*First Judicial District of Pennsylvania's ("FJD")  
Request for Proposal ("RFP")*

*Workstation and Other Office Furniture Project*

**VENDOR'S QUESTIONS AND ANSWERS ("Q&A")**

- Basement ("EMU"): 5 duplex outlets

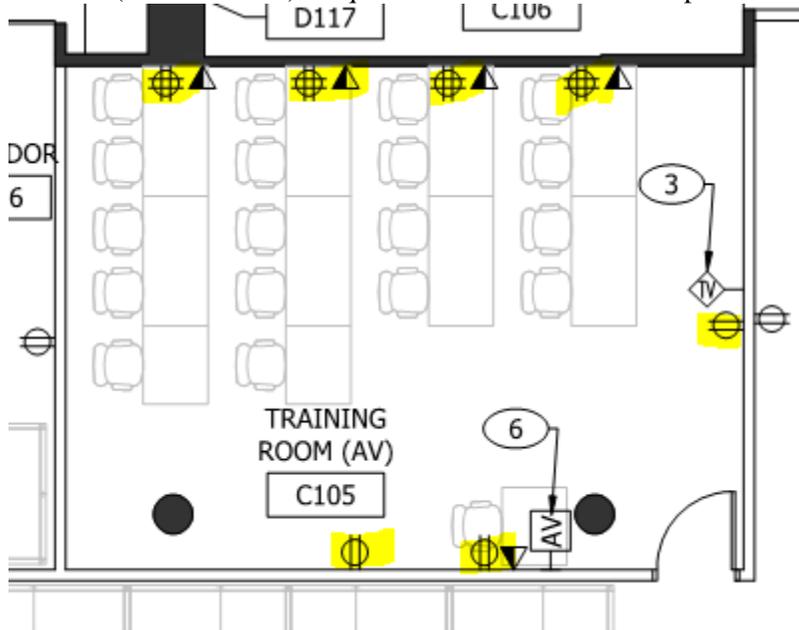
**Q11. *Training table requirements (powered, flip/nest/ganging, casters, modesty) and what seating is requested for these rooms?***

See response to Q5 above. Training Rooms on Attachment 1 (Rev.) show a floor raceway to provide power and data to the respective tables. Accordingly, the below snapshots represent the Architect's planned electrical needs for the various lecture training and computer training rooms:
